ADDENDUM NO: 2

PROJECT: Clarksville Community Schools Interior Improvements

PROJECT NO: 2025014 DATE: 08/20/2025

DRAWING NUMBER A201

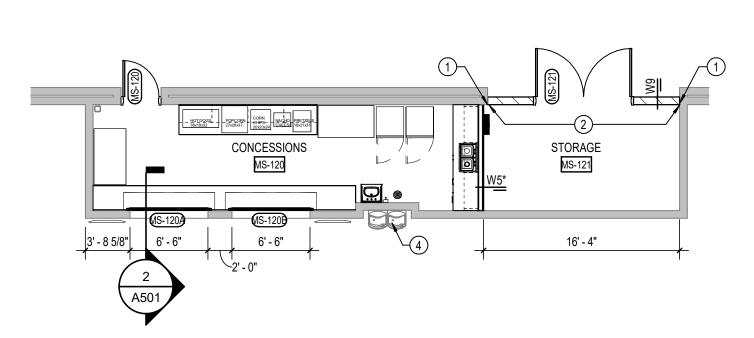
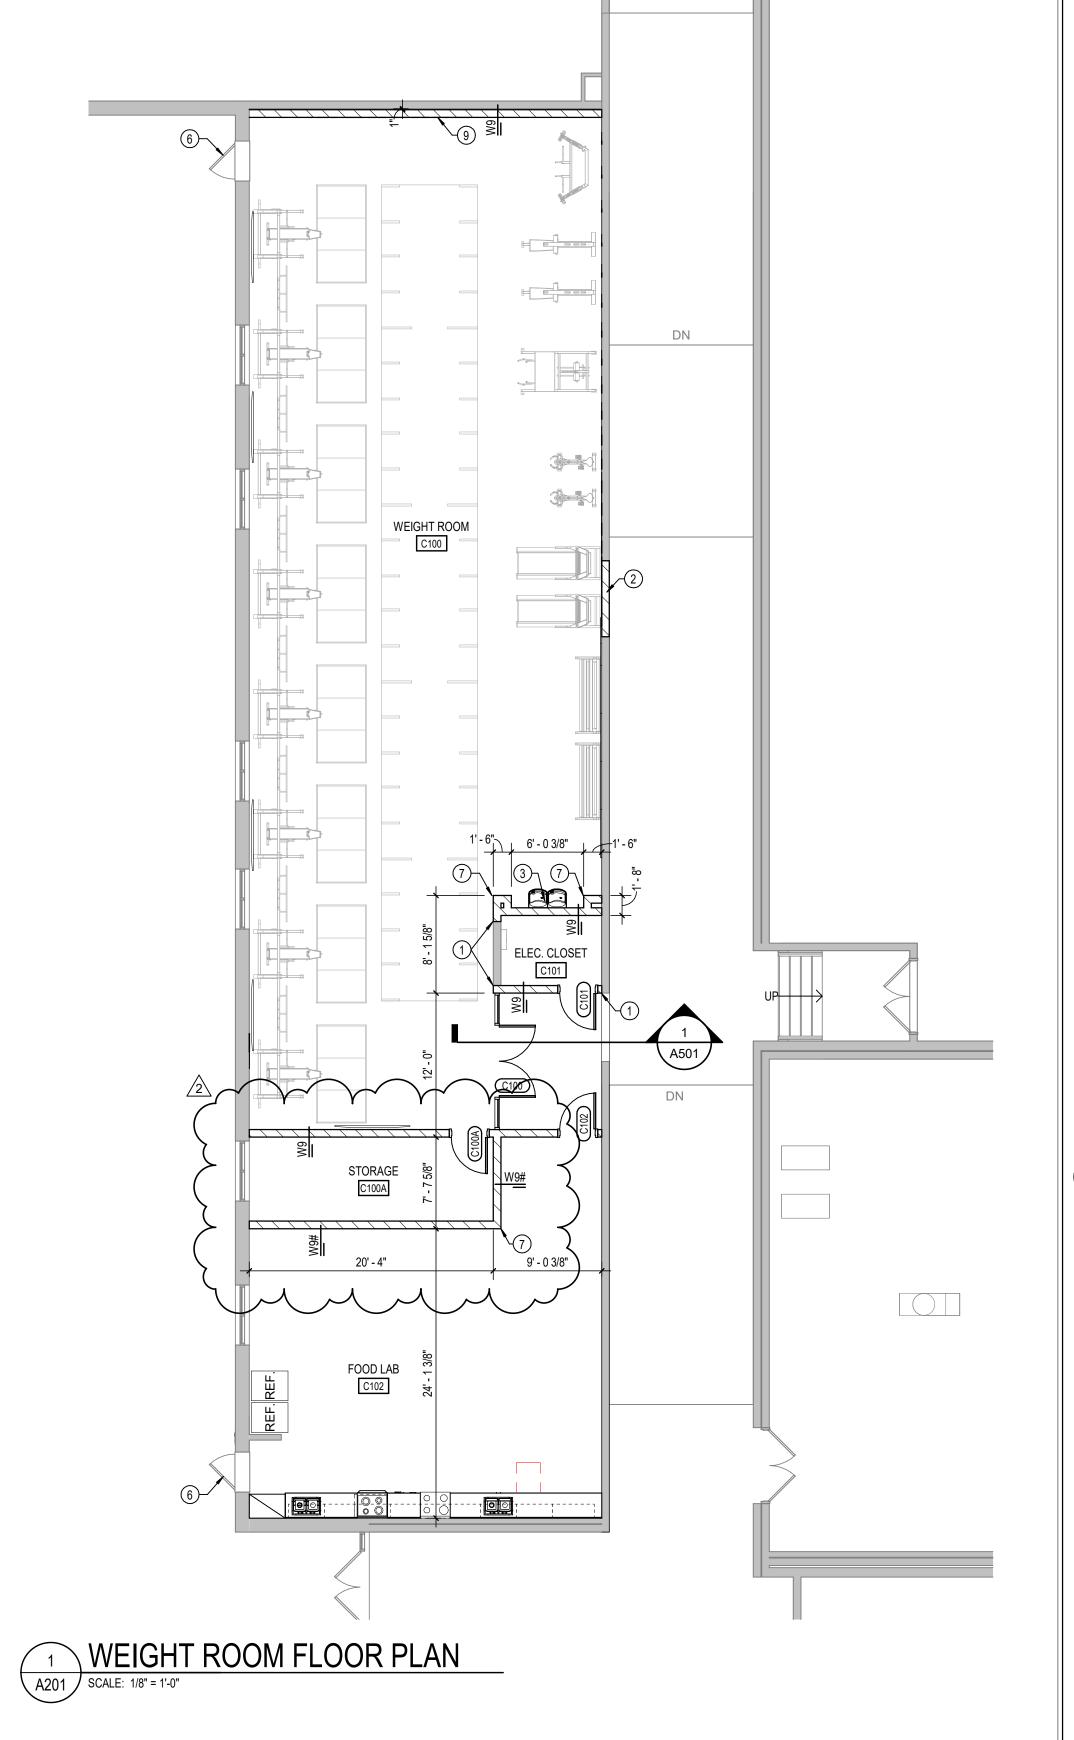
- 3.1 A201 GROUND FLOOR PLANS
 - A. Add Wall Type Note #7 ALL WALLS SHALL EXTEND TO DECK, IF A WALL TYPE SYMBOL IS FOLLOWED BY A "#" THE WALL SHALL TERMINATE 8" ABOVE HIGHEST ADJACENT CEILING.
 - B. Deck height in the Weight Room area is assumed to be +/- 18'-4" AFF
- 3.2 A701 RESTROOM PLANS
 - A. Detail 6/A701 Clarification on which walls can terminate above ceiling.

- 6. WALL TYPES ARE ASSUMED TO BE CONTINUOUS WITHIN THE SAME PLAN SURPRICE UNTIL ANOTHER TAGUE SHOWN. . ALL WALLS SHALL EXTEND TO DECK, IF A WALL TYPE SYMBOL IS FOLLOWED BY A "#" SYMBOL, THE WALL SHALL TERMINATE 8" ABOVE HIGHEST ADJACENT
